## ***Interactive comment on “A novel model for simulation of nitrate in aquifers” by Roohollah Noori et al.***

Response to Reviewer' Comments on: <https://doi.org/10.5194/hess-2018-222>

Response to Comments of Reviewer #1

Figure 3

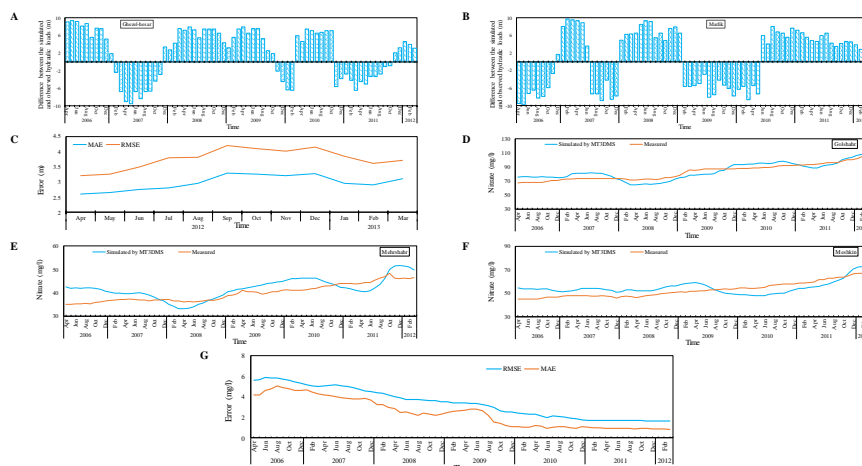
Comment: Page 8, line 5: looking at only the difference can be misleading. Examining timeseries is also important to assess trends. Response: We agree and have now added the trends of measured nitrate concentrations and simulated ones by MT3DMS model. We have also added another figure that properly shows the trends of RMSE and MAE averaged over the study area during the calibration period {Please See Supplement File, Track Change Version (Page 8: Lines 17 – 22; Figure 3D to 3G)}.
